From: Rob Kelly [REDACTED]
Sent: Saturday, January 13, 2024 7:03 AM
To: Tom Ramsey <tramsey@Piedmont.ca.gov>; Jennifer Long <jlong@Piedmont.ca.gov>; Conna McCarthy <cmccarthy@piedmont.ca.gov>; Betsy Andersen <bandersen@piedmont.ca.gov>; Jen Cavanaugh <jcavanaugh@piedmont.ca.gov>
Subject: item #3 January 16th meeting

The City of Piedmont is the applicant for a design review permit seeking to replace an existing pedestrian bridge across Bushy Dell Creek in Piedmont Park (711 Highland Avenue) with a modified design.

RE: **Piedmont Park Bridge over unnamed creek draining to Bushy Dell Creek**

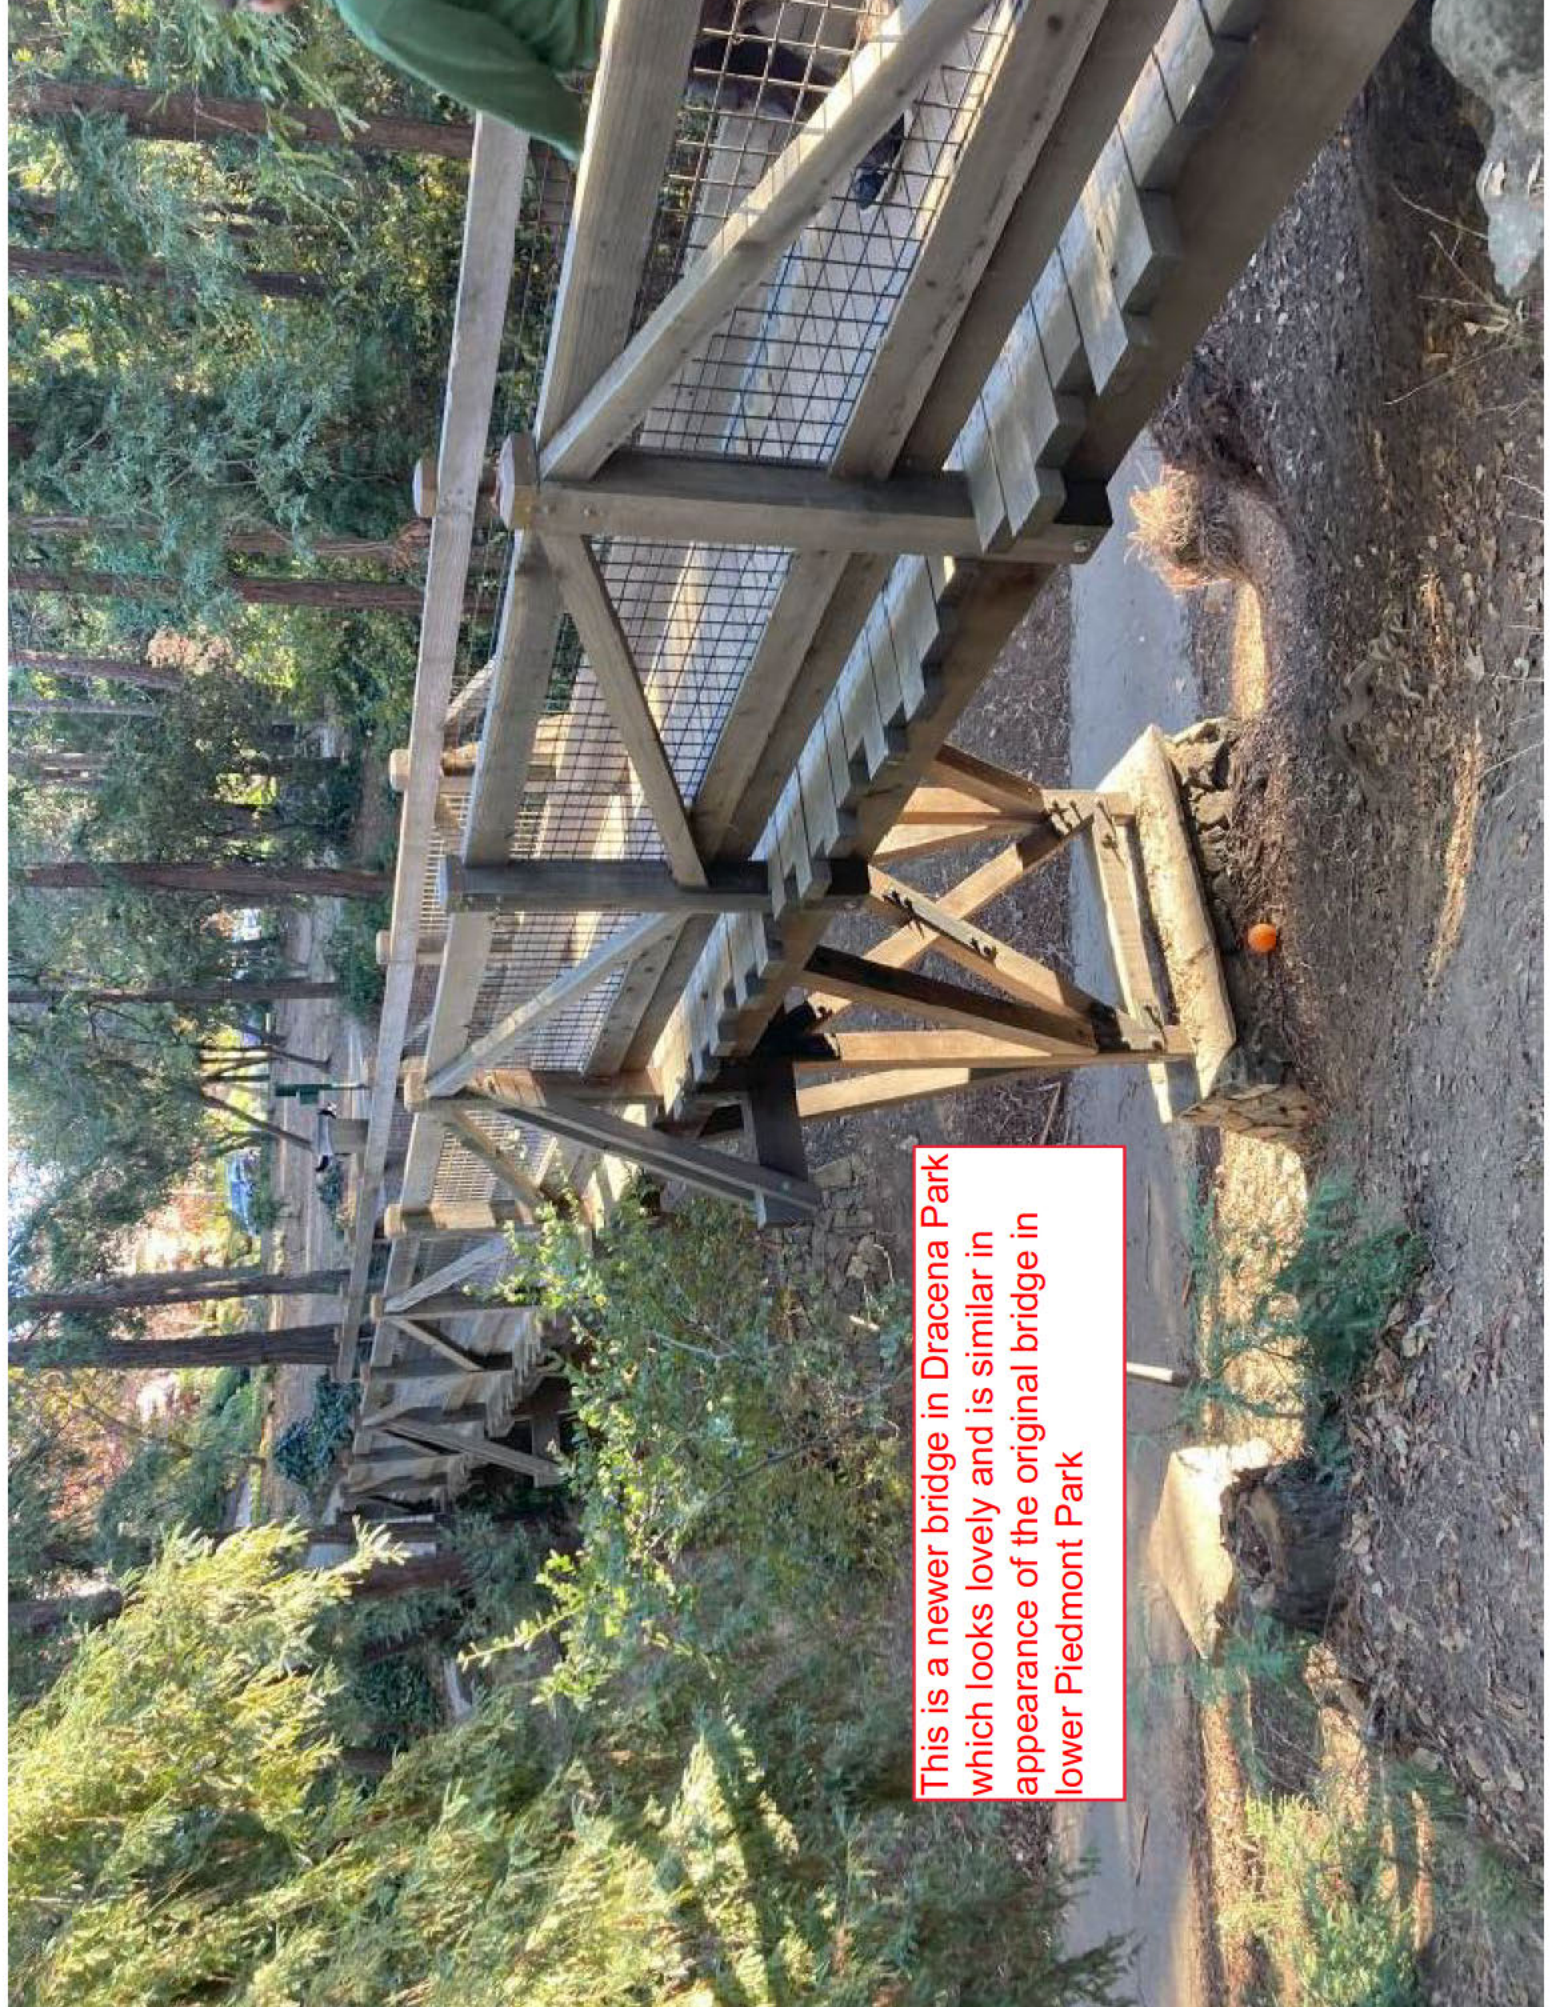
2. Replace as-is appearance is more appropriate to the local environment.
3. Existing foundation appears to be in excellent condition. This is visible from below and above. This can be substantiated for re-use by a licensed structural engineer.

4. Bridge is failing due to rotting wood, not for any other reason.
5. This creek tributary is dry almost all of the time. The soils engineer "did not observe significant evidence of recent or incipient... slope instability". Visual inspection indicates that there is no current slope instability at the foundation.

I spoke with the soils engineer, Ben Pappas, who said that repairing the existing bridge was not considered and his soils report applies to the proposed new bridge. Given that the creek is dry

most of the time and underlain by rocky soils, he stated that the likelihood of the bridge falling into the creek with a person getting hurt would be a low probability.

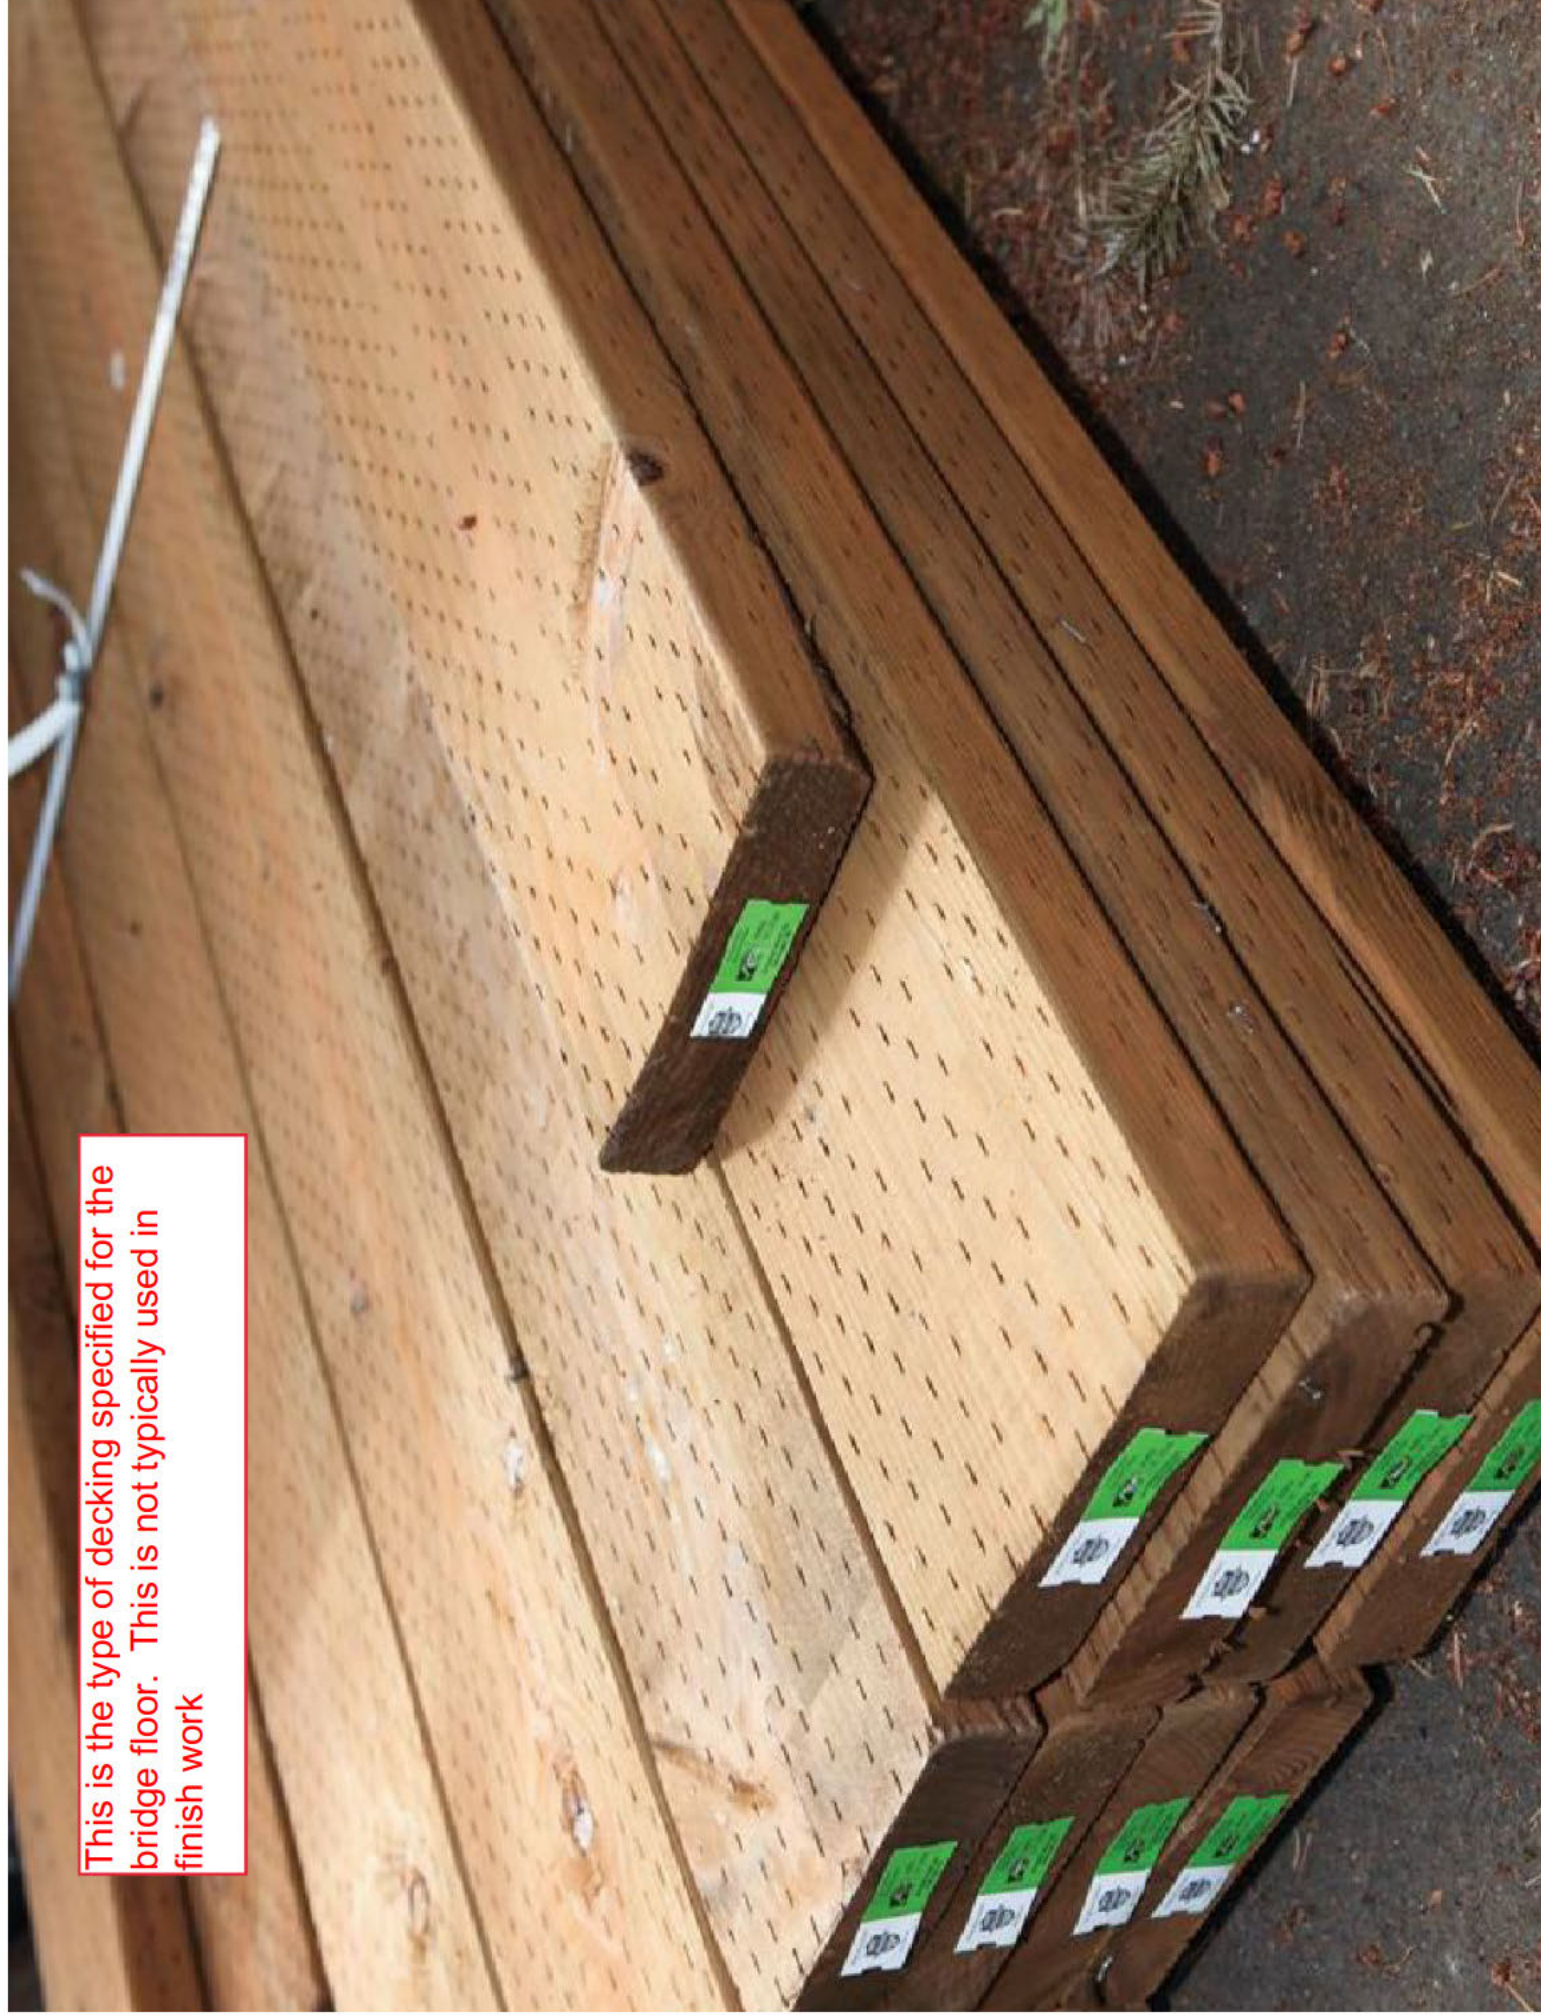
This is a newer bridge in Dracena Park which looks lovely and is similar in appearance of the original bridge in lower Piedmont Park

This is what the new bridge could look like. The actual design is left to the lowest bidding contractor. The bid documents specify that it be this style of bridge, a "1/2 through "H" section with bowstring pratt truss". The decision to use this type of design is its purportedly low cost.

This is the type of decking specified for the bridge floor. This is not typically used in finish work
